170 THE BRIDLE PATH

# SUMMARY OF FENCE EXEMPTION SUBMISSION REQUEST

## 170 THE BRIDLE PATH HEIGHTS

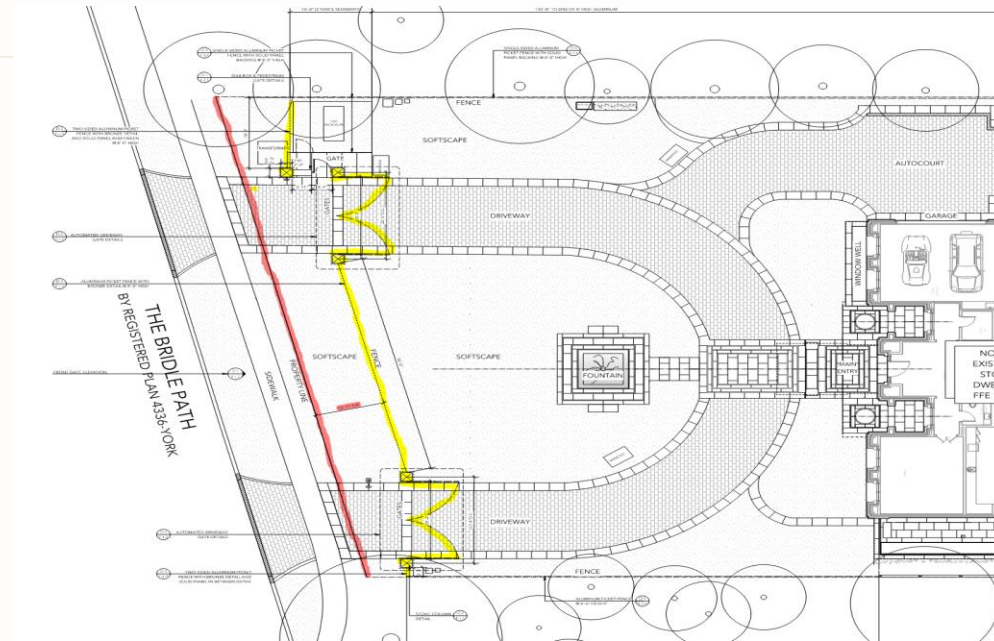
The existing front yard fencing consists of stone columns measuring approximately 2.7 metres (8.9 feet) in height, along with aluminum fencing and driveway gates measuring 2.5 metres (8.0 feet) in height, forming a continuous enclosure along the frontage. These heights exceed the permitted limits under Section 447-1.2(B)(1), which regulates fence height in front yards and within 2.4 metres of a lot line abutting a public highway.

Front Aluminum fence at 8' high (2.44m) **By law calls for 2.0m**

Front Structures @ 8'9" high (2.67m) **By law calls for 2.0m**

Front Aluminum Driveway Gates @ 8' high (2.44m) **By law calls for 2.0m**

Front Middle Aluminum fence @ 8' high (2.44m) **By law calls for 2.0m**

Please refer to page 4 for height comparison. Also, on page 6, examples of other houses in the neighbourhood with higher gates, fences and structures have been included for reference

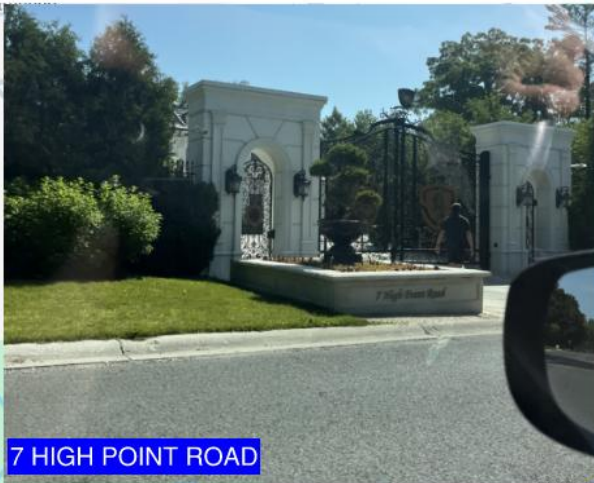
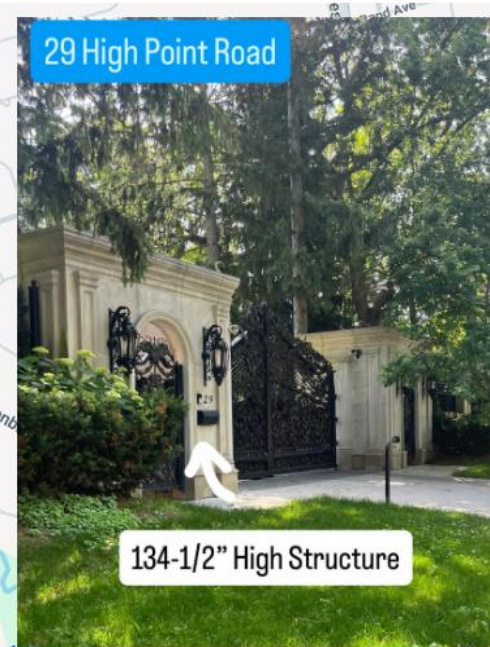
**The next page shows a drawing elevation of such fence and gates as well as photographs of other houses in the area with higher gates, fences and structures**

1 LAYOUT PLAN  
P-1.0 SCALE: 1:250

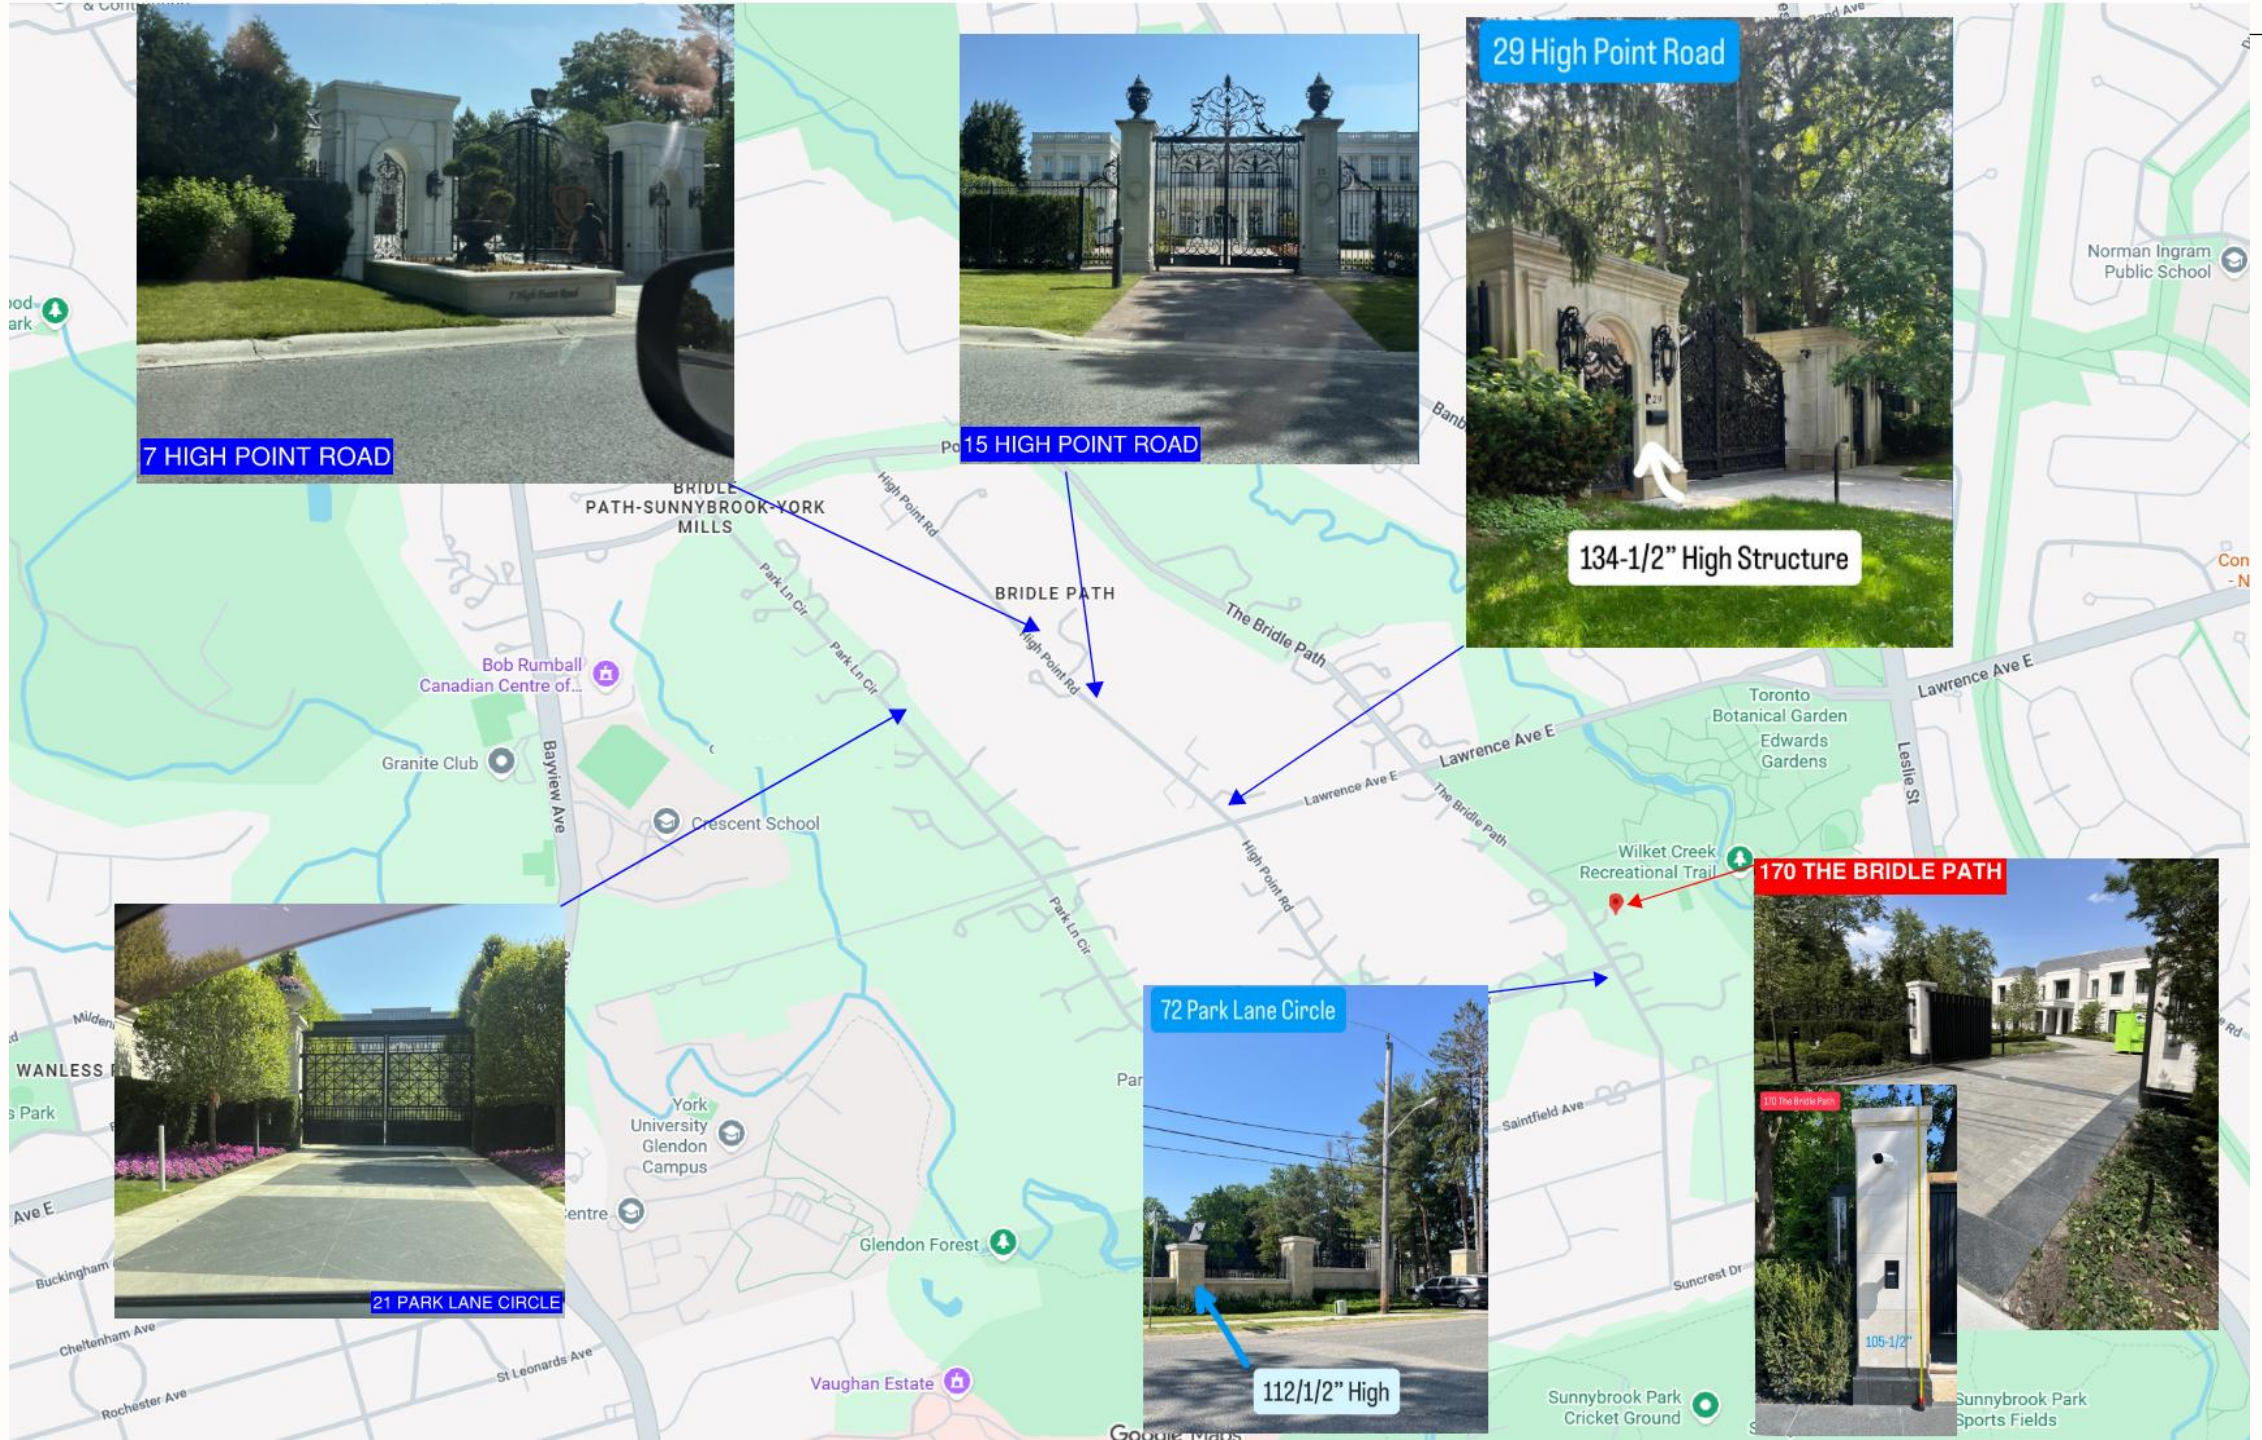
The pool enclosure on all sides includes commercial-grade composite fencing with solid backing supported by aluminum framing. These materials are not typically permitted for use in permanent pool enclosures, contrary to Section 447-1.2(A)(5), which restricts materials to those ordinarily used for fencing unless otherwise permitted

Along the north and east property lines, the chain-link fence has a mesh size of approximately 50 millimetres (2 inches), exceeding the maximum permitted 38 millimetres (1.5 inches) for residential pool enclosures, as required under Section 447-1.3(E)(2)(a).

Under the City of Toronto website: *Fences – City of Toronto* – it lists fencing material that are not allowed however, composite materials is not denoted. We also would like to point out that we have complied with the required heights on both the North and South Property lines as well as, the bylaw states the fencing cannot be climbable which the fence we have installed is not climbable.

170 the bridge path have already changed this fencing material out to 1-1/2" mesh to comply. Photos can be found on page 10 of this document.

# POOL DECK FENCE EMBEDMENT LIMITATIONS

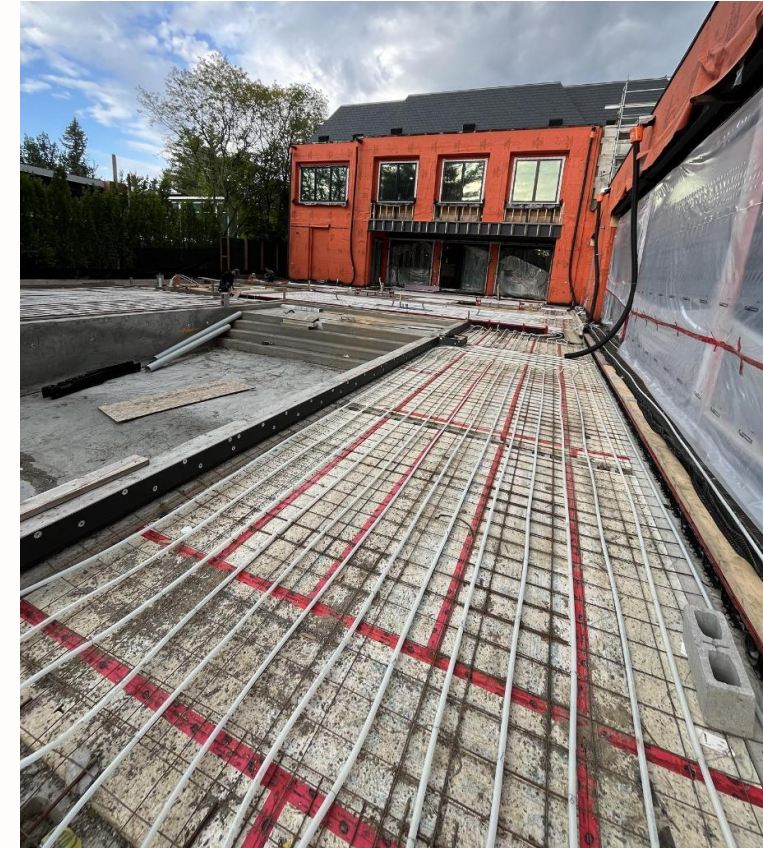
The enclosure includes chain-link fence posts that are anchor-bolted into the concrete pool surround. This does not comply with Section 447-1.3(E)(2)(a), which requires that gate and terminal posts be embedded to a minimum depth of 760 millimetres in concrete with a minimum diameter of 200 millimetres.

Due to there being living space below the pool deck, along with snow melt hydronic tubing below the deck pavers, the required 760mm embedment depth was not possible. Thus, the anchoring detail was modified and engineered to accommodate this site condition. Please refer to page 9 for photos.

Due to the limitation of living space below this area as well as snow melt tubing below the paved terrace, we had to change the anchoring of the posts.
